## STAFF REPORT

Planning Commission Meeting: June 9, 2025

<b>Application:</b>	<b>PR25-0010: Preliminary Site Development Plan for Premier Business Park</b>
<b>Location:</b>	Southwest of S. Kansas Avenue and E. Southgate Street
<b>Owner:</b>	Bryon VanLerberg, Premier Foundations
<b>Applicant:</b>	Tim Tucker, Phelps Engineering Inc.
<b>Architect:</b>	Larry Lisbona, Lisbona Architects
<b>Staff Contact:</b>	Andrea Morgan, AICP; Planner II

*Diagram of Building A and Building B*

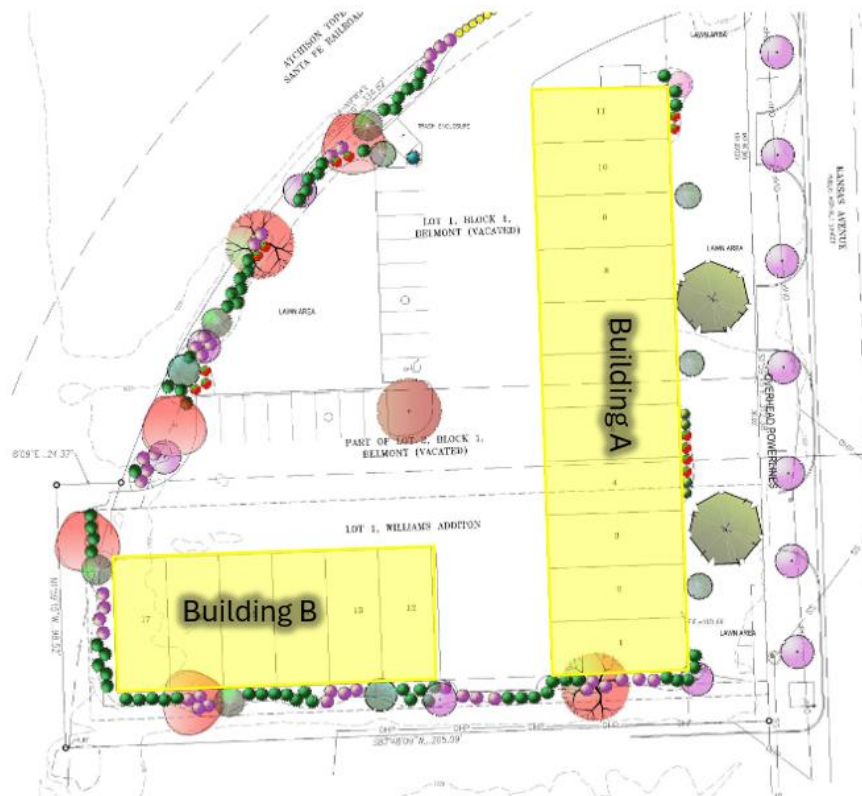
1. UDO 18.15.020.G.10.b, which requires *that secondary façades must use a combination two (2) Class 1, Class 2, or Class 3 materials on 40% of the façade.* The west façade of Building A and the north and west façade of Building B are being requested to utilize one (1) Class 3 material.

The applicant is requesting a waiver to reduce the required building material combination and percentage on one (1) secondary façade for Building A and two (2) secondary façades on Building B. Staff is supportive of the request because the applicant is exceeding the Class 1 and 2 material percentages on the eastern primary façade of Building A, which is visible from S. Kansas Avenue. The applicant also incorporates several horizontal and vertical articulation methods and a variation of high-quality materials on the primary façade that will be softened by the landscaping. The east façade provides a high quality design not typically seen on industrial buildings. The east façade is proposing alternating metal suspended canopies and metal awnings over all windows. Parapets of varying heights with the decorative parapet detail in the center to create visual interest. Variation in materials are used to create distinct bays and visual interest. In addition, the secondary façades are not visible to the public and abut railroad rights-of-way and railroad owned property.

1. A waiver is granted from UDO 18.15.020.G.10.b to permit one (1) Class 3 material on the west façade of Building A and the north and west façades of Building B .
2. Exterior ground-mounted or building-mounted equipment including but not limited to, mechanical equipment, utilities' meter banks and coolers must be screened from public view with three (3) sided landscaping or an architectural treatment compatible with the building architecture.
